April 6, 2018

**Re: Drainage Compliance Letter for Proposed Les Schwab Tire Center on Lots 3 & 4 – Meridian Crossing Filing Number 1**

FIGURE 1

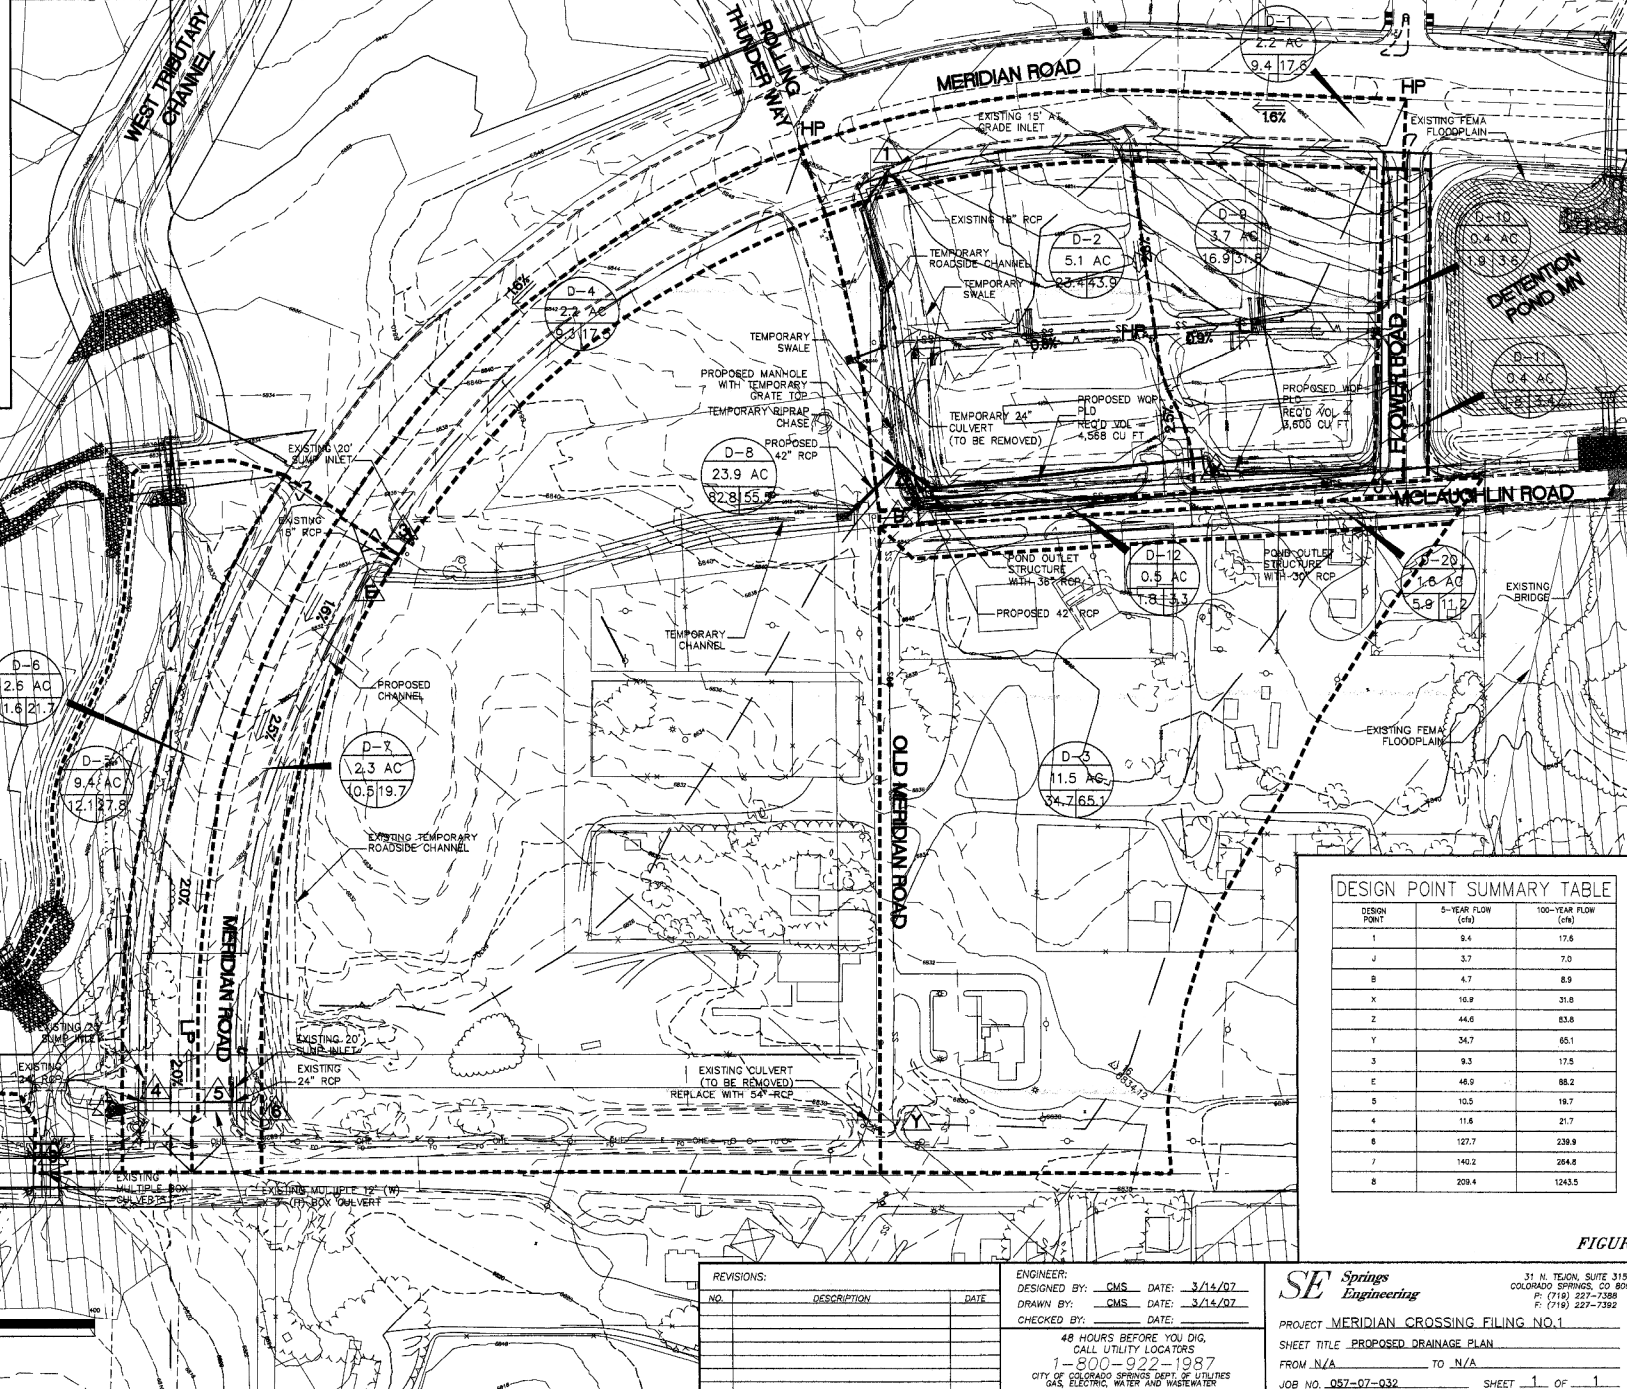
Please acquire an easement for the 24" storm line that you anticipate constructing on Lot 5. Since Lot 5 is owned by same company as Lots 3 & 4, you may add this easement to the proposed re-plat.

Please provide documentation that allows you to construct on the adjacent property.

note, all area within you site must pass through a WQ facility. what you call OS-1 and OS-3 are also required to pass through if ANY impervious area is within them. they are not off site basins, they are within your site. please provide justification as to why you are not, please address the four step process, please describe what flow may go to lot 5 from your OS-3 and state that it is anticipated to be routed through the existing WQ facility.
